Test Monitoring Center

Sequence X Information Letter 23-2
Sequence Number 8
June 9, 2023

SUBJECT: Revisions to Figure 2.

FIG. 2 Blowby System Configuration and Measurement Routing

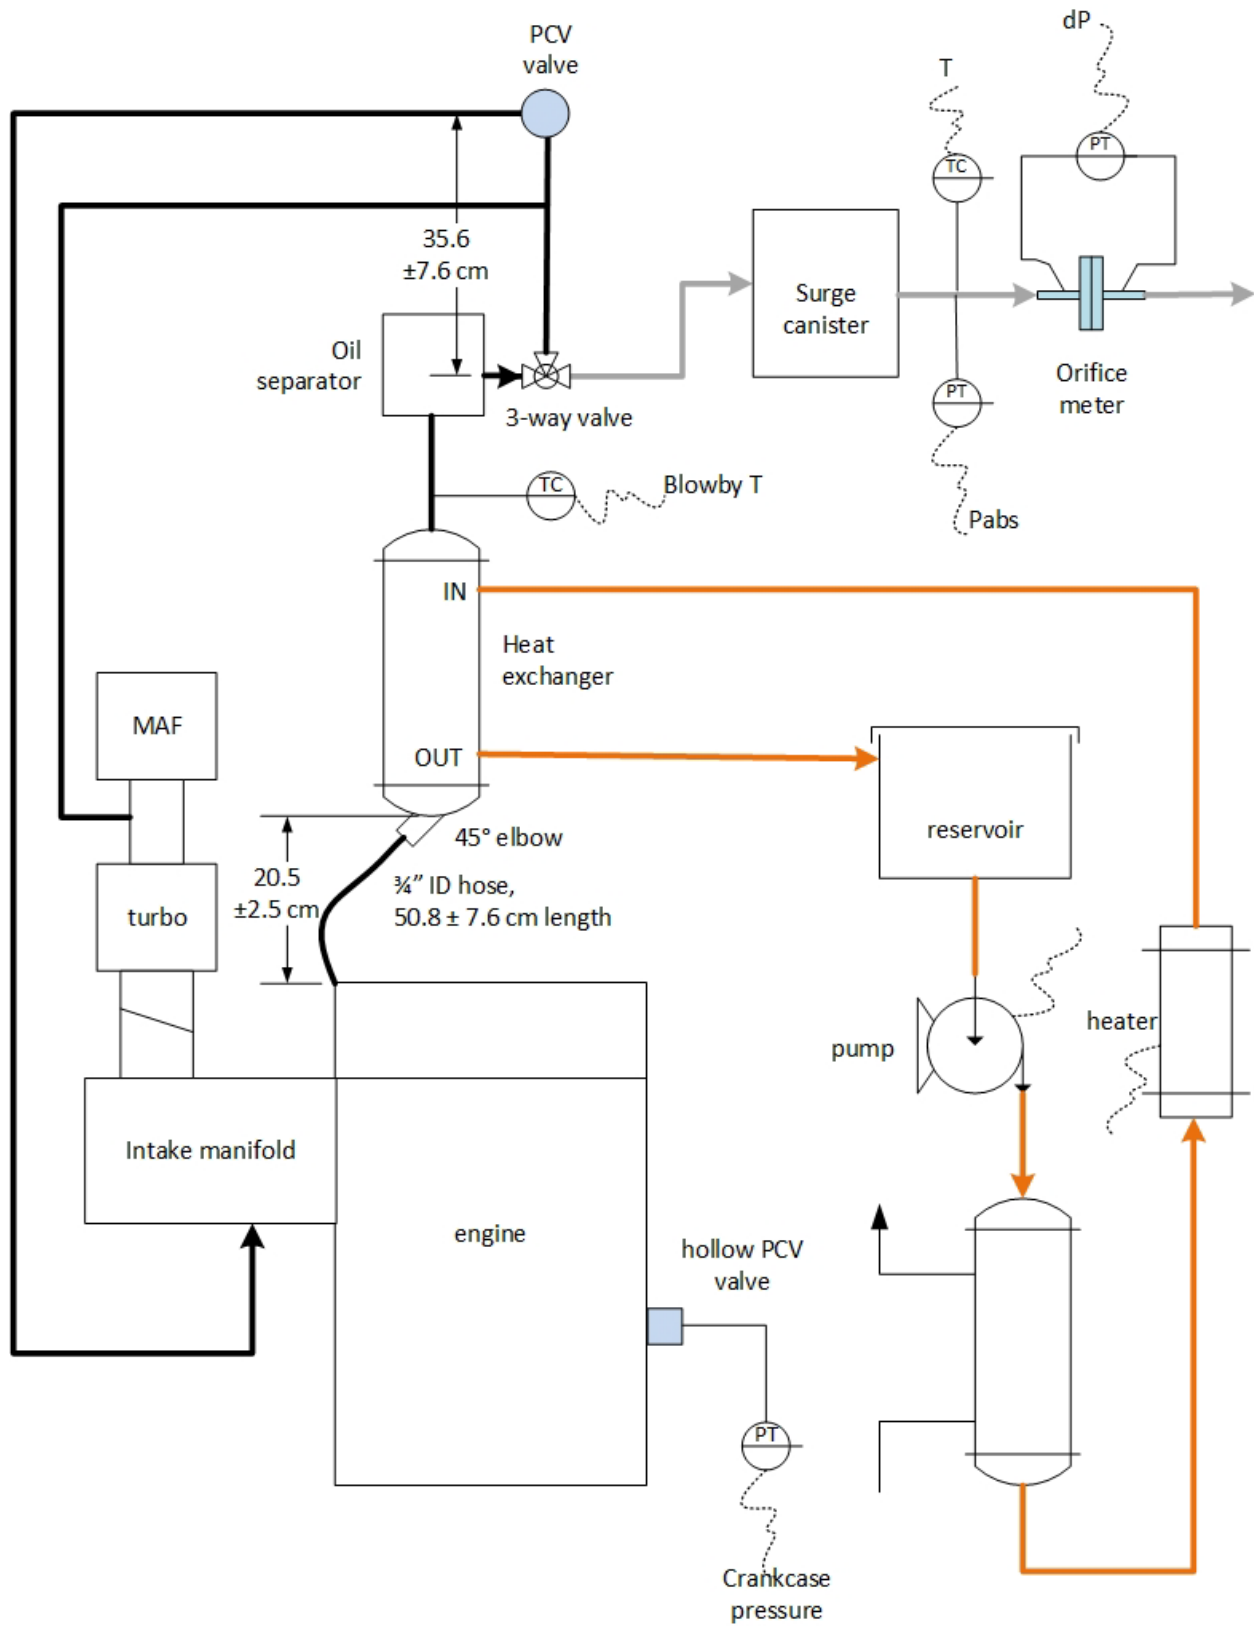
During the May 2, 2023, meeting, the Sequence X Surveillance Panel identified several incorrect items in the blowby system shown in Figure 2. A normally open valve was incorrectly shown and the distance between the PCV valve discharge and the intake air return line was dimensioned in error. Figure 2 has been updated to remove these inconsistencies.

The revised Figure is attached. These changes are effective with the issuance of this letter.
